COMMENT

432.01
(3.0)*

Your proposed emergency classification/notification/immediate action scheme, presented in Appendix I and II of the WNP-2 Emergency Plans, is not clearly compatible with that of the State of Washington and those of local agencies. Whereas you have established three classes for which offsite notification and/or support would be advisable or necessary, the State has six such classes. Additionally, the affected counties have a priority scheme which your plan does not recognize.

ORGANIZATION CHART

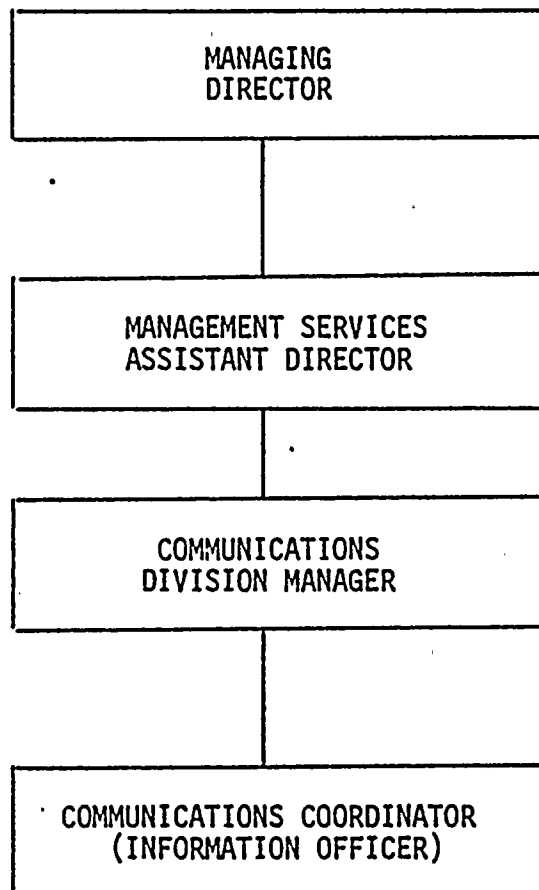
In Section IV.B of Appendix IX of your proposed Emergency Plans, you describe the duties of your Information Officer. Revise your proposed Emergency Plans to make provisions for the participation of your Information Officer in coordinated drills with State and local agencies. Provide a line of succession of authority from the Managing Director for the purpose of providing news releases which are coordinated with State and local agencies, to the public in the event of an emergency.

The following change will be made to Section IV.B of Appendix IX
page -10-*

See the following chart for the line of succession.
